PUBLISHED BY FORD MOTOR COMPANY OF CANADA, LIMITED, FORD, ONTARIO, CANADA

New Design Camshaft and Bearing

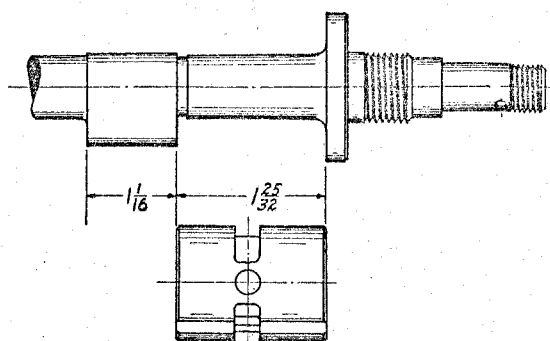
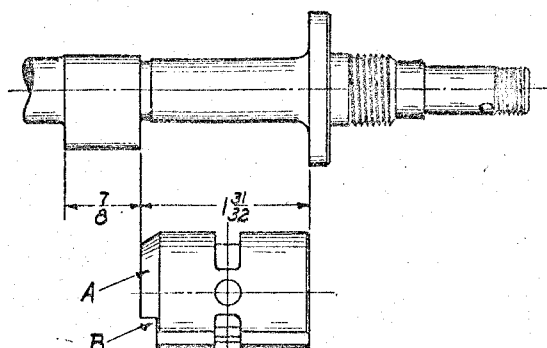
An engineering change was recently made in the model T camshaft 3041-410 by lengthening No. 1 exhaust cam $\frac{3}{16}$ " and shortening the camshaft front bearing T 411 the same amount. Figs. 28 and 29 illustrate the changes that have been made in these parts. It will be noted that the notch "B" and the 30 degree chamfer "A" on the rear end of the old style bearing has been eliminated on the new type.

The length of No. 1 cam on the new design camshaft has been increased from $\frac{7}{8}$ to $1\frac{1}{16}$ ". This change of course decreased the distance between the cam and flange, the distance between these points being $1\frac{25}{32}$ " on the new shaft and $1\frac{31}{32}$ " on the old type.

The old type camshaft bearing will be listed as 3042-411AR while the new type will be listed as 3042B-411B, both bearings being carried in service stock. The new type camshaft will be carried under catalog No. 3041, Factory No. 410 the same as the old type, as the old design will no longer be available after present stocks are exhausted.

Due to decreasing the distance between No. 1 cam and flange on the new type shaft, when selling a camshaft front bearing it will be necessary to ascertain whether the car in which it is to be installed is equipped with the old or new type camshaft.
